Addendum No. 2 Date: October 03, 2024

Project: Addition to Linden High School for the Linden City Board of Education Linden, Alabama

MCKEE PROJECT NO. 22.315 ALABAMA DIVISION OF CONSTRUCTION MANAGEMENT NO. 20240569

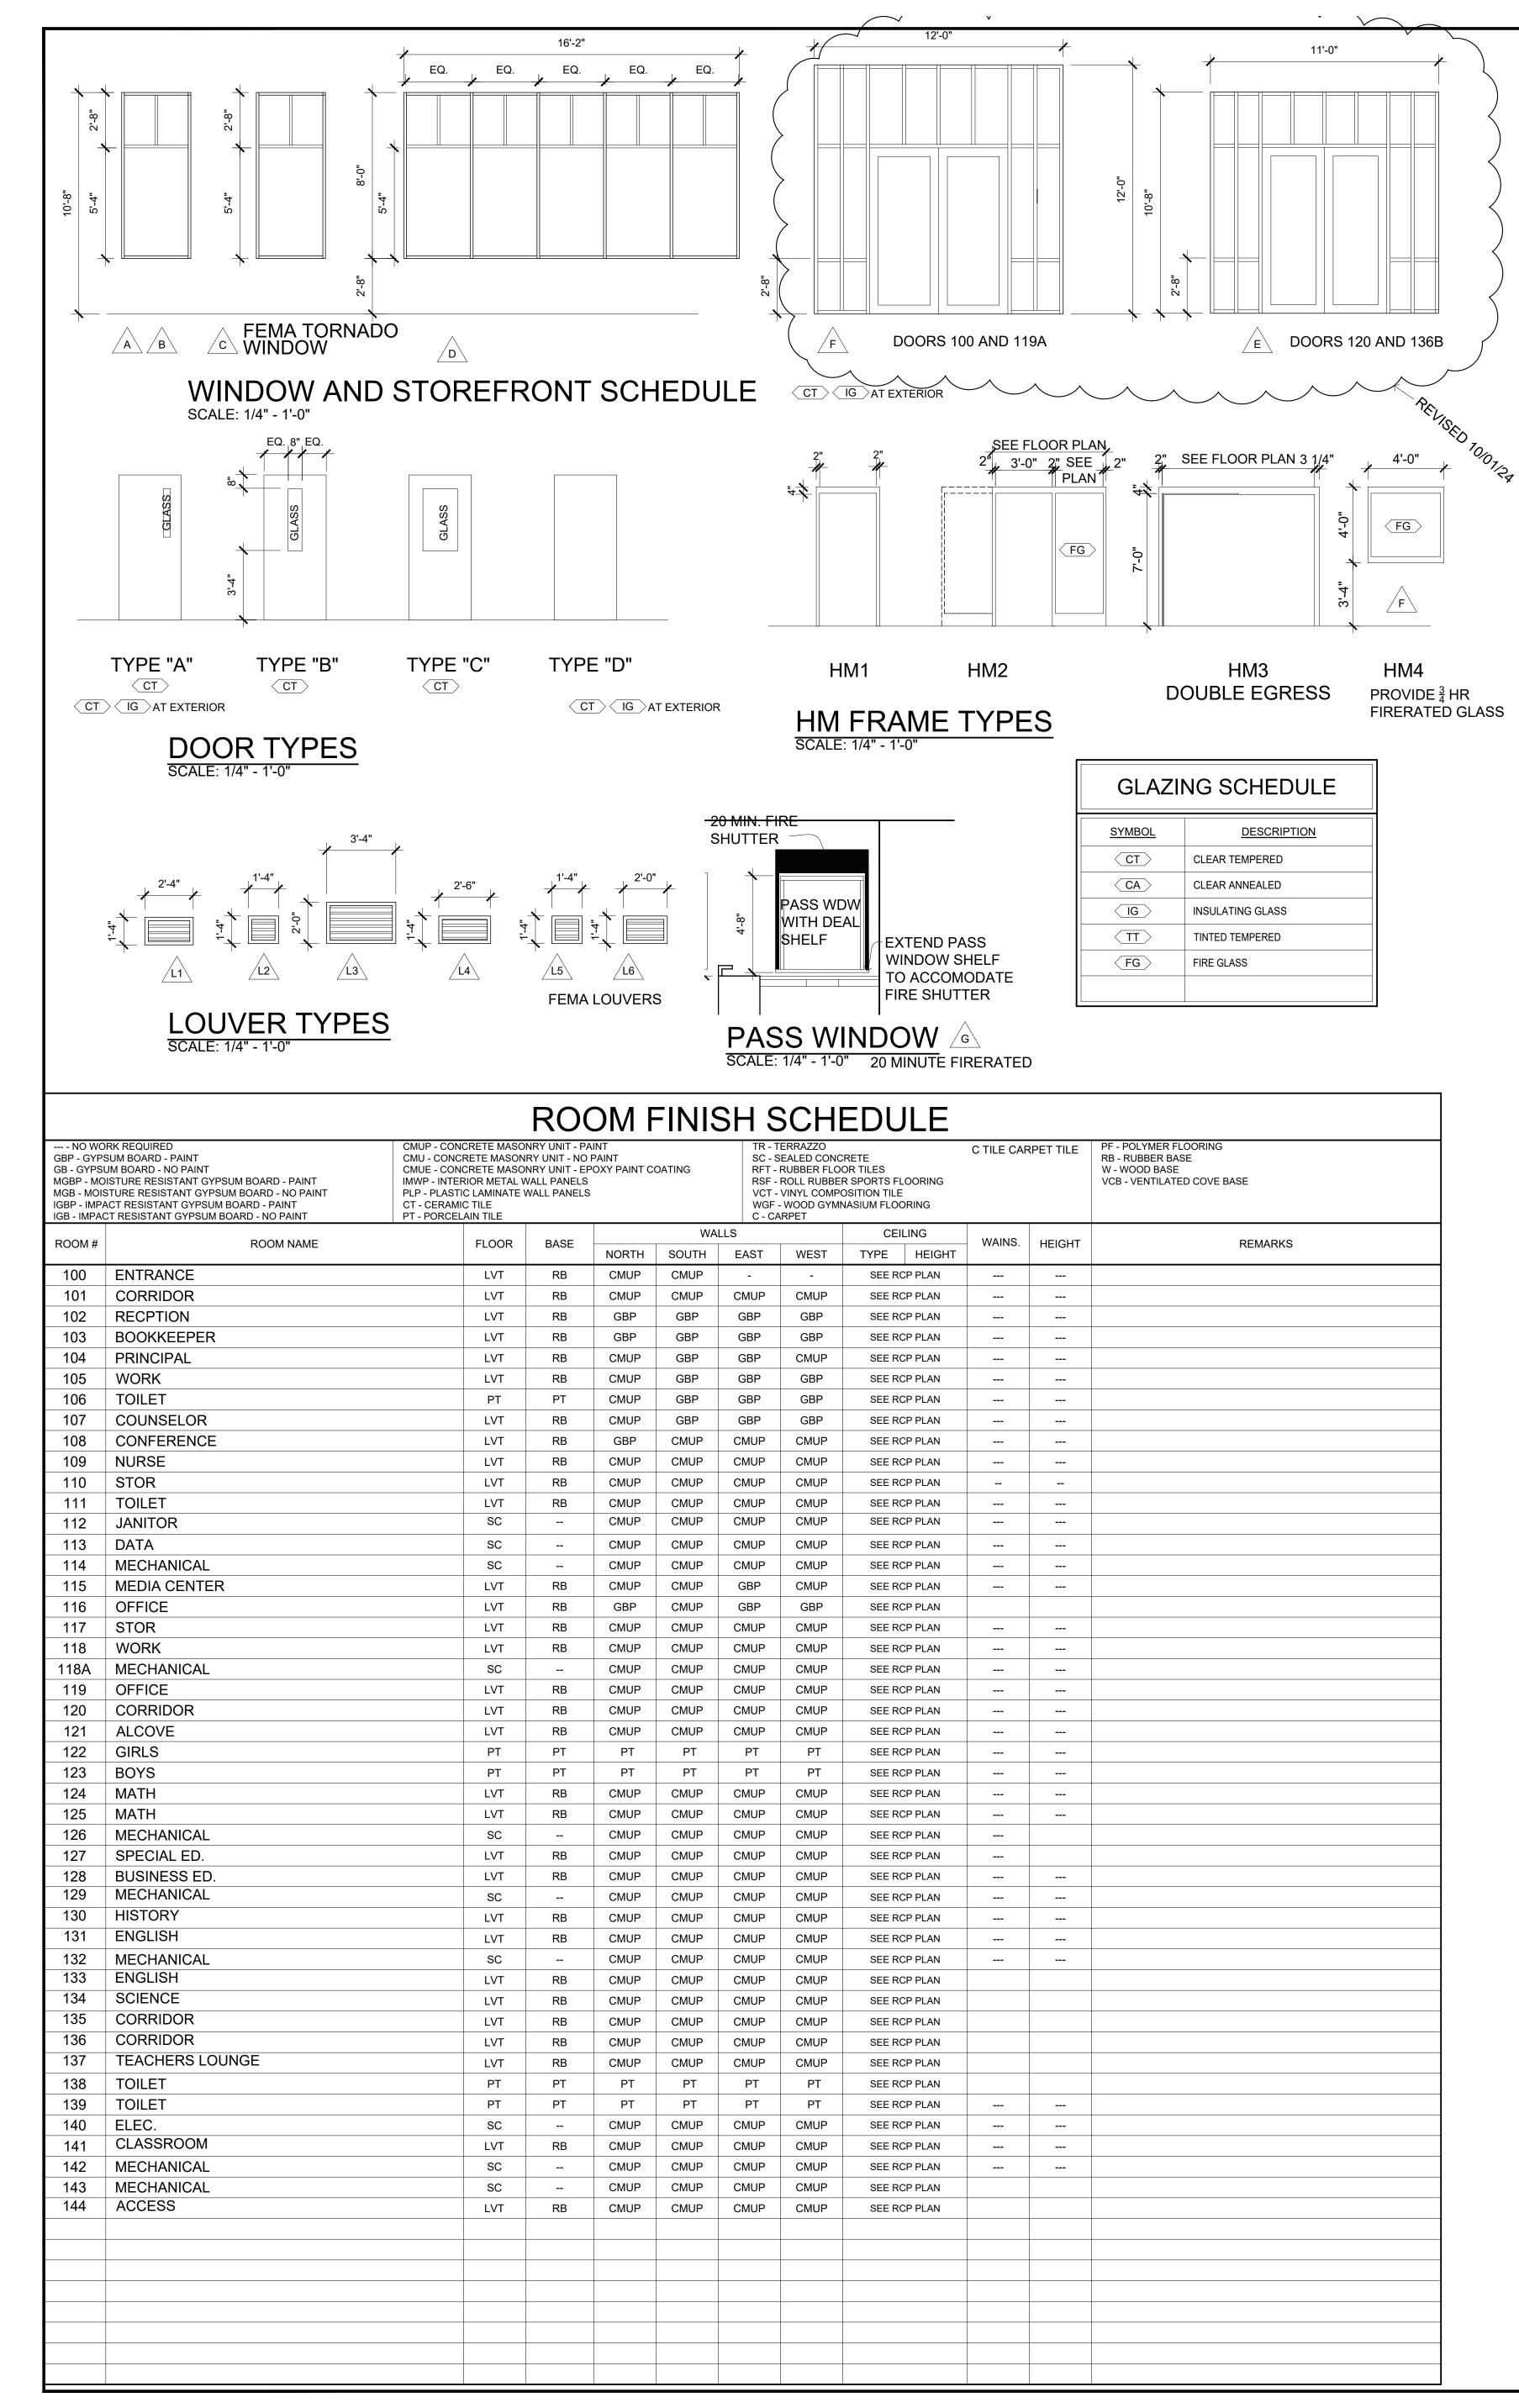
Question: Reference Sheet G1.0. Please clarify the jumbled text in Access Room 144.

Answer: "AREA 810 SF. OCC 41, & "WORK STATION PROVIDED BY OWNER"

SCHEDULES SHEET TITLE : MCKEE JOB # : 22-315 DRAWN BY : RT DATE: 8/27/2024 REVISED DATE: 9/12/24 REVISED DATE: 10/01/24 **REVISED DATE:**

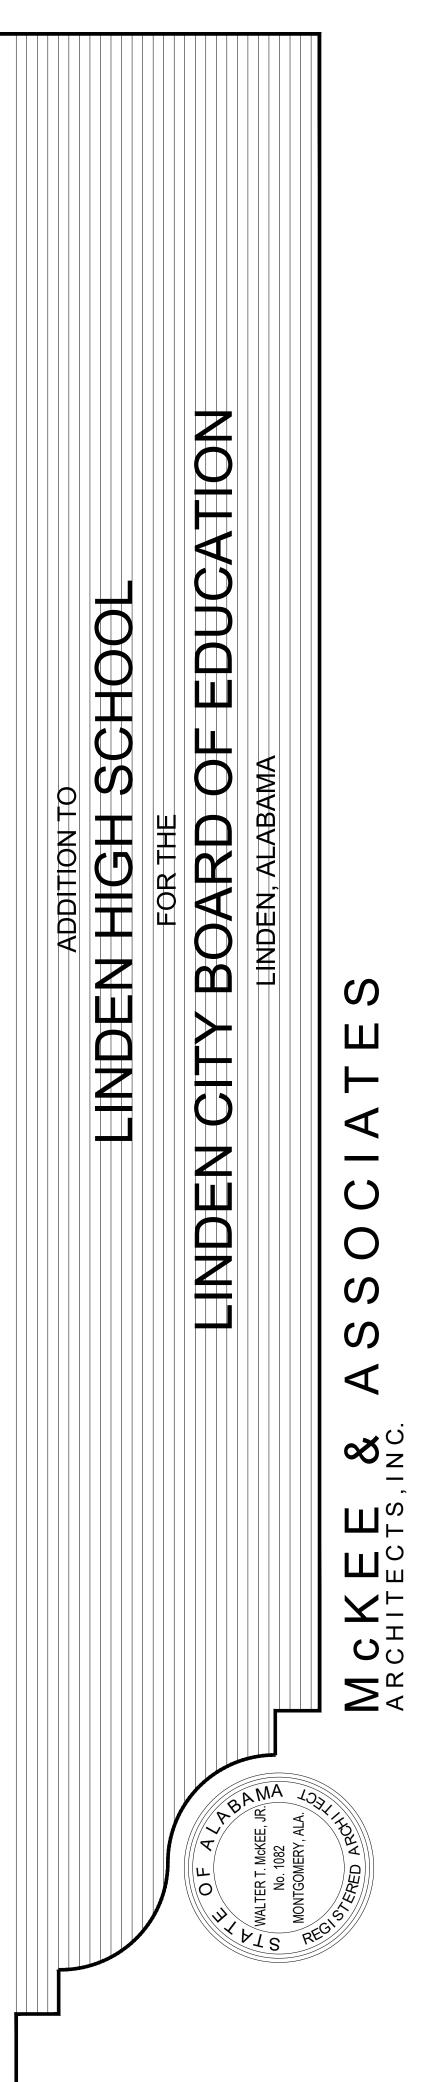
Question: On page A8.1, please confirm whether Window A, B and D are Storefront or Window. Window C is the Fema Tornado Window.

Question: There is also a discrepancy on Window "D" and Storefront "D" location on the drawings. There are 2 elevations marked as "D". Please advise.

Answer: See revised sheet A8.1 Included herein.

Answer: See revised sheet A8.1 Included herein.
